Planning Commission Staff Report

File # 6Z25-DCA-000552-2025

Public Hearing and Recommendation to the City Council for a Zoning Map Amendment for Approximately 13 Acres of Property at 4271 S., 4225 S., and 4273 S. 2700 W., from Professional Office (PO) to Site-Specific Development Residential (SSD-R).

Public Hearing and Recommendation to the City Council for a Zoning Text Amendment to Taylorsville Municipal Code, Adopting Chapter 13.45, Standards for the SSD-R Motion Zoning District.

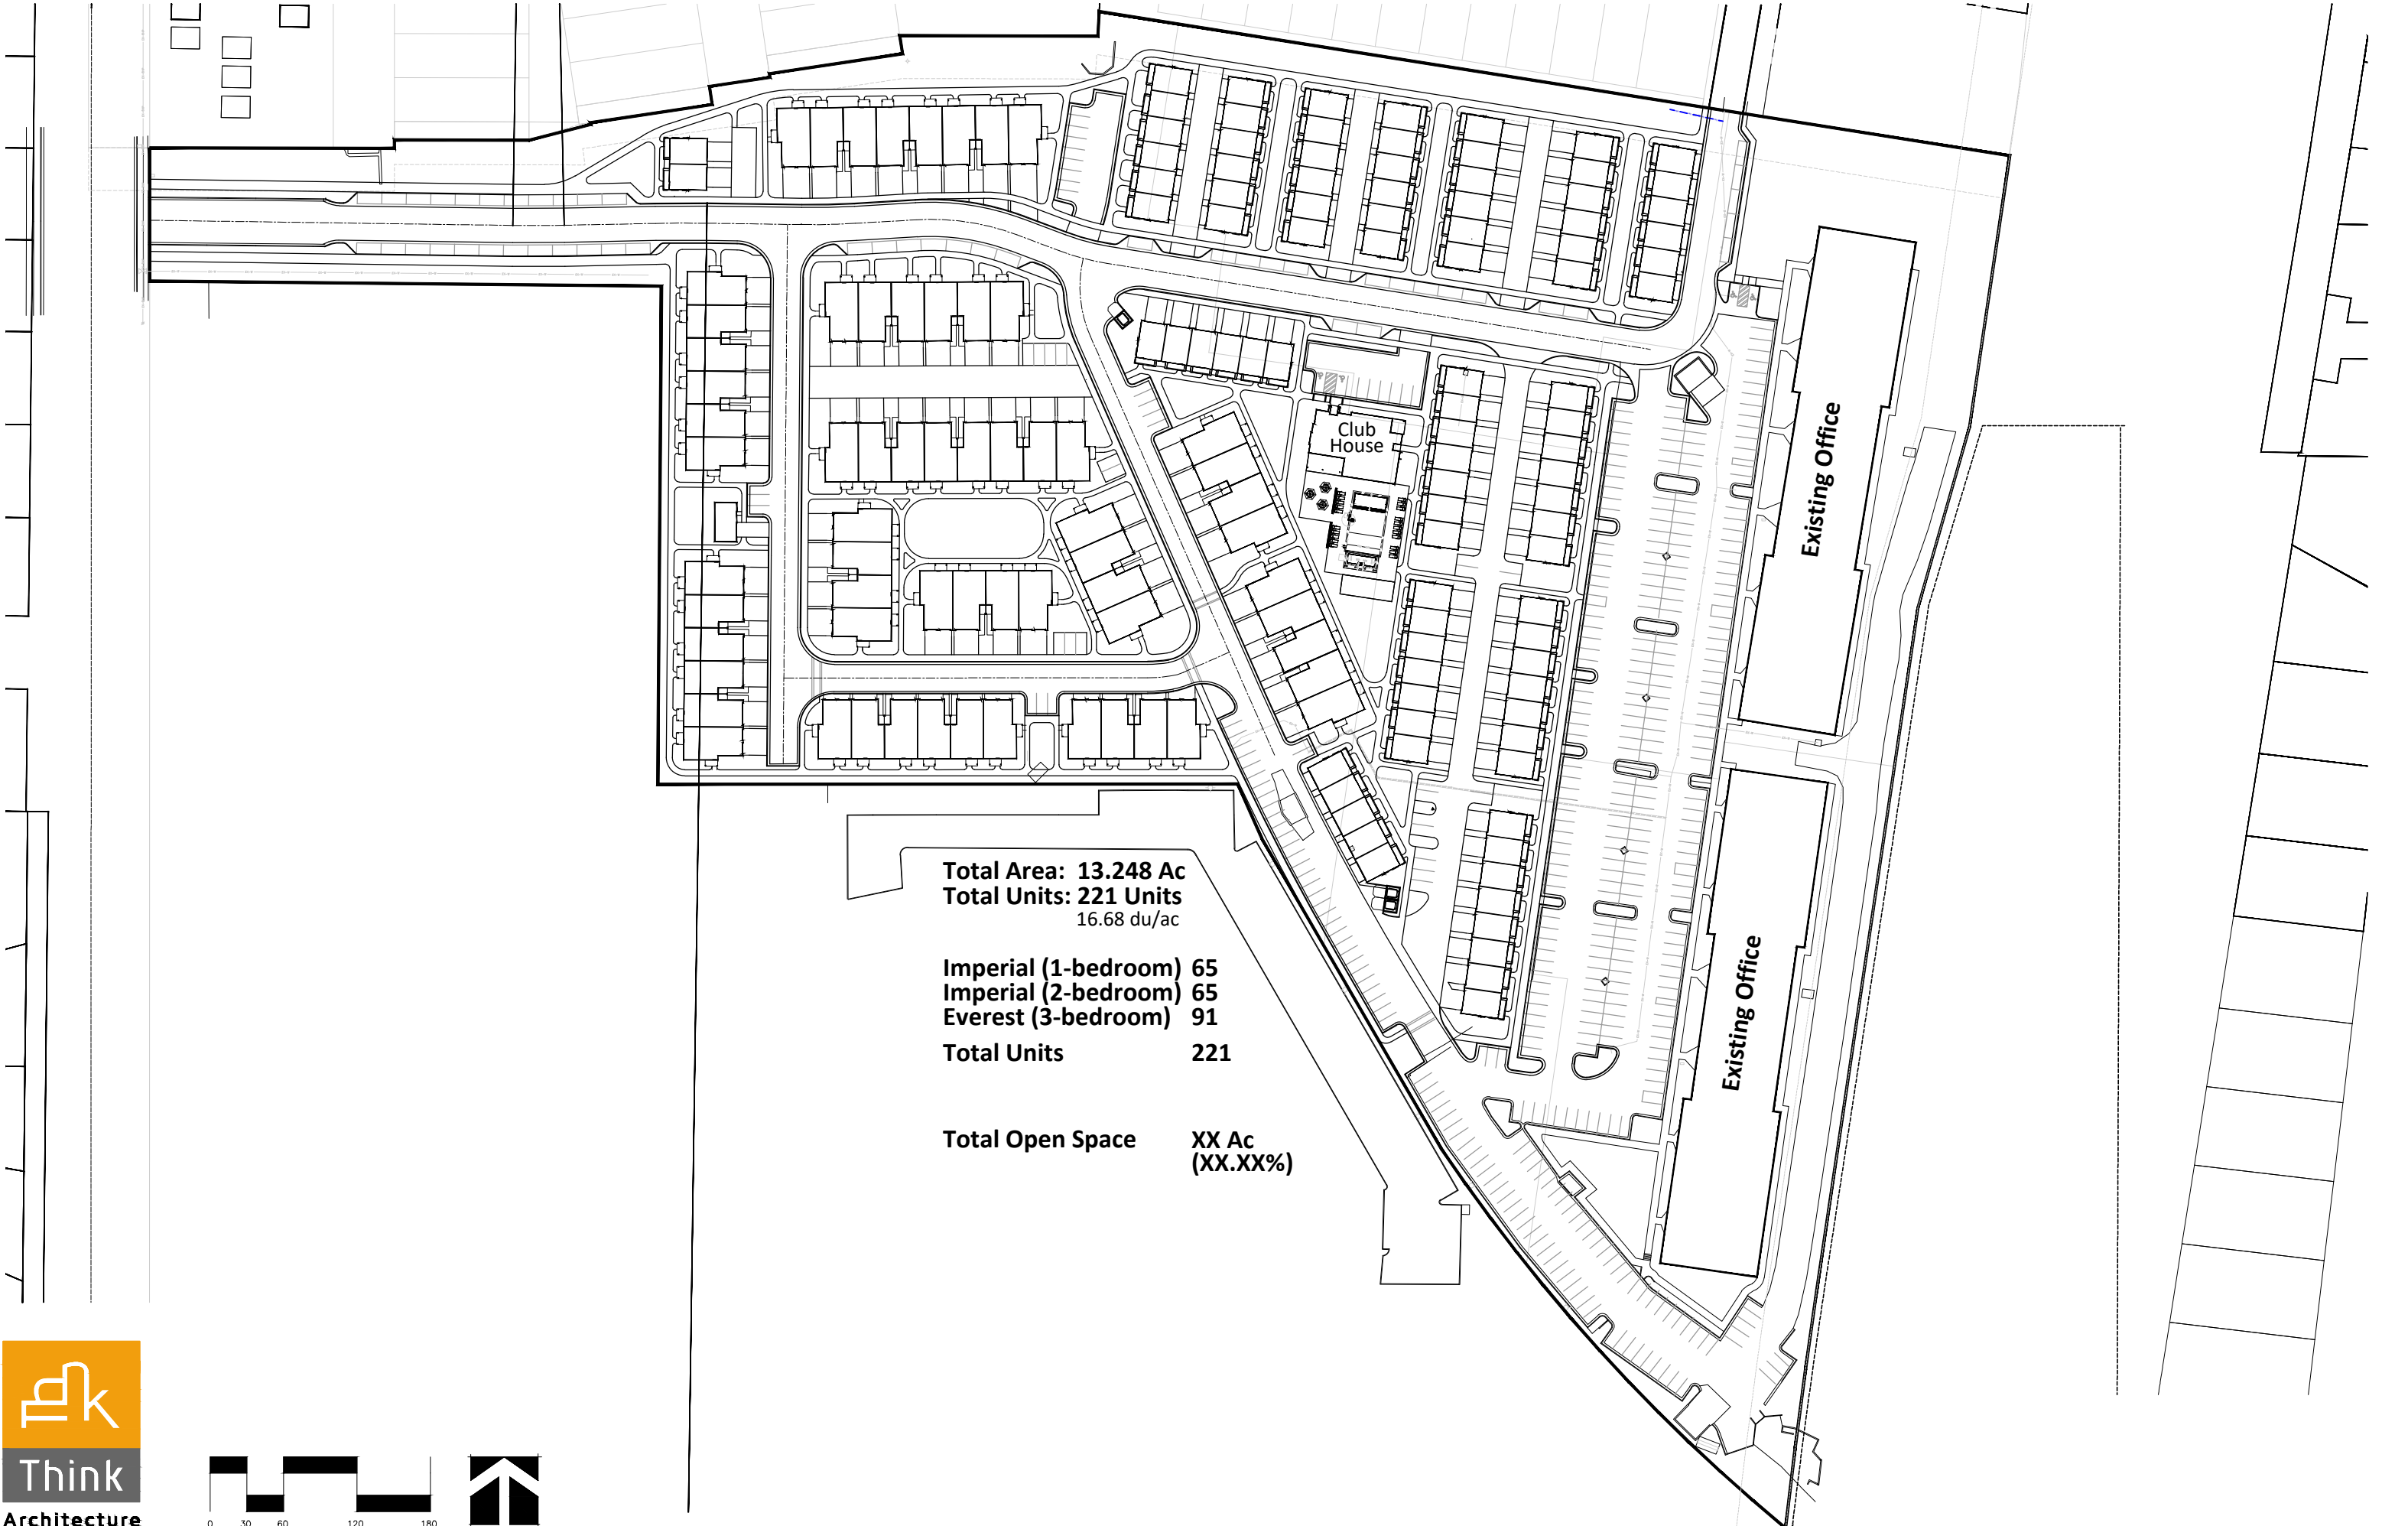
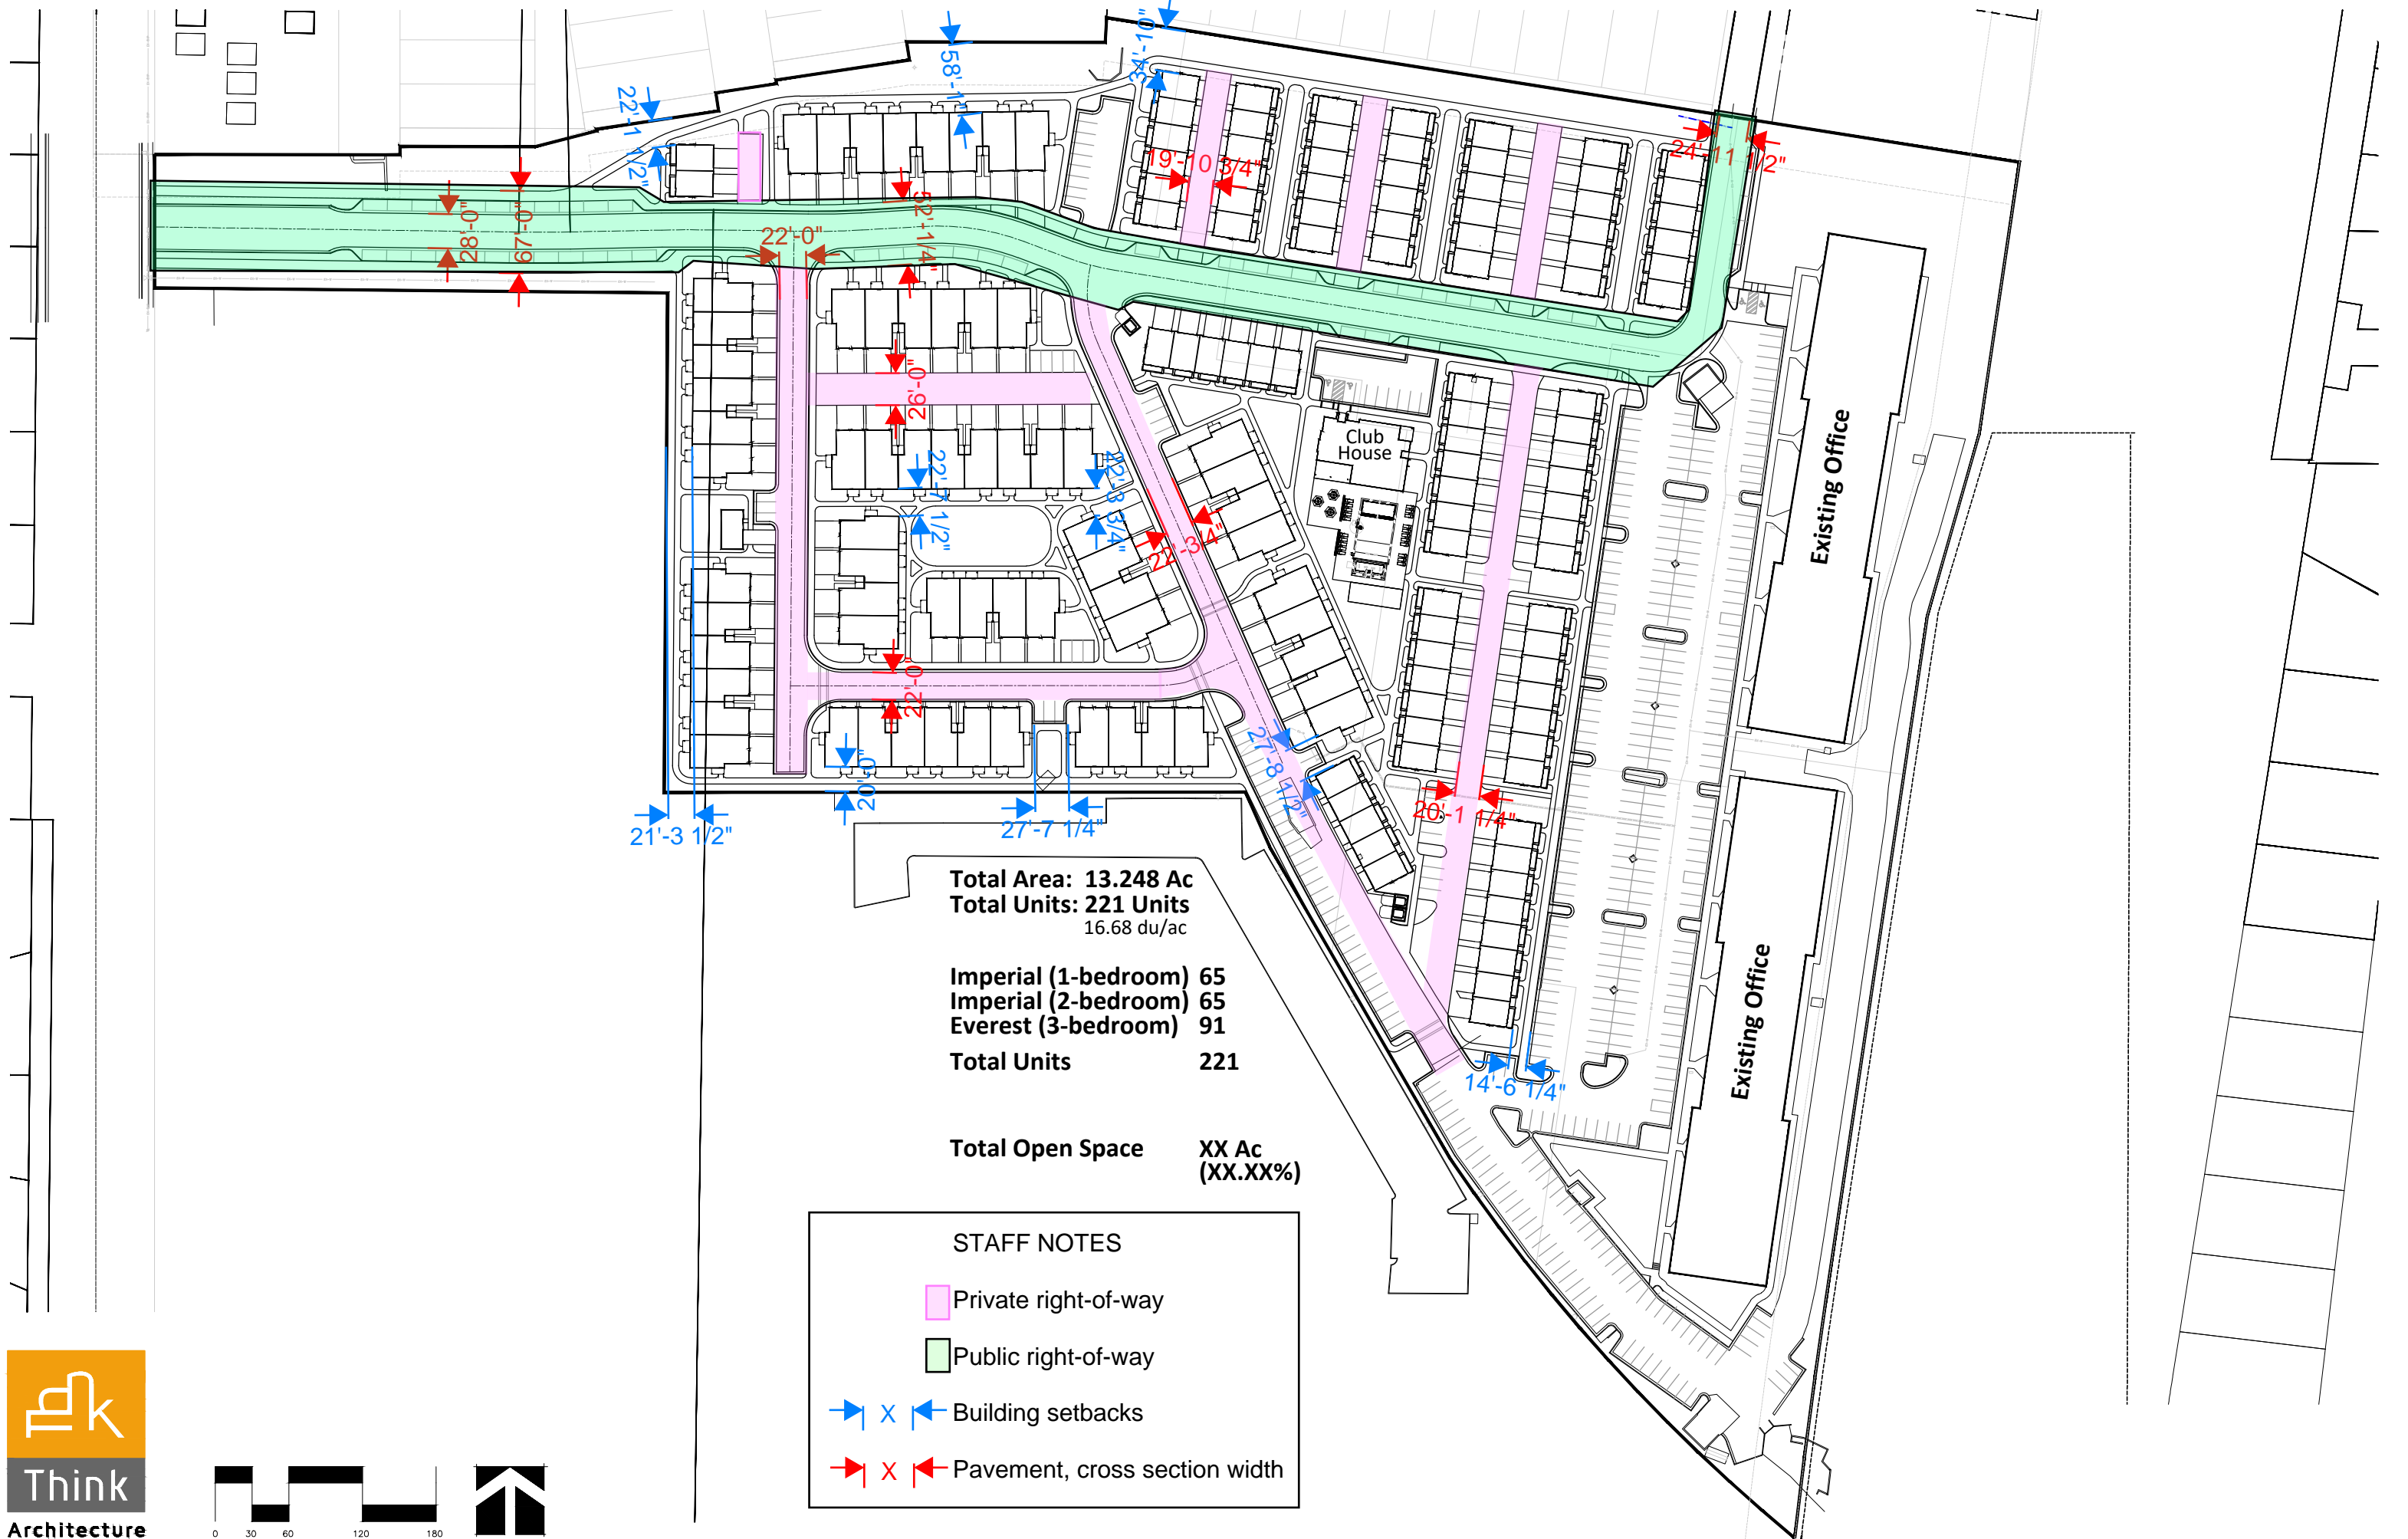
The site features a blend of walkable elements such as some rear-loaded units, 5 and 8-foot sidewalks, narrow drive aisle with bump outs along public road for traffic calming, and parallel parking buffers along segments of sidewalks. Townhomes fronting the public road are designed with 20-foot-long driveways to prevent vehicle overhang onto the sidewalk. Amenity areas are provided throughout the site as well as a club house and pool at the center of the project for residents.

To minimize impacts on existing residential properties a buffer between existing neighboring residential is shown, ranging from approximately 22 feet to 58 feet. The proposed townhome styles along this northern border vary between the two- and three-story products shown in Exhibit I. However, the entire northeastern portion of the project is proposed to consist of the three-story style and maintain a 35-foot landscaped buffer between residential that will contain a walking path and function as useable open space for the residents.

The submitted concept plan does not include an open space calculation. Taylorsville Land Development Code provides different standards for open space:

Total Open Space XX Ac
(XX.XX%)
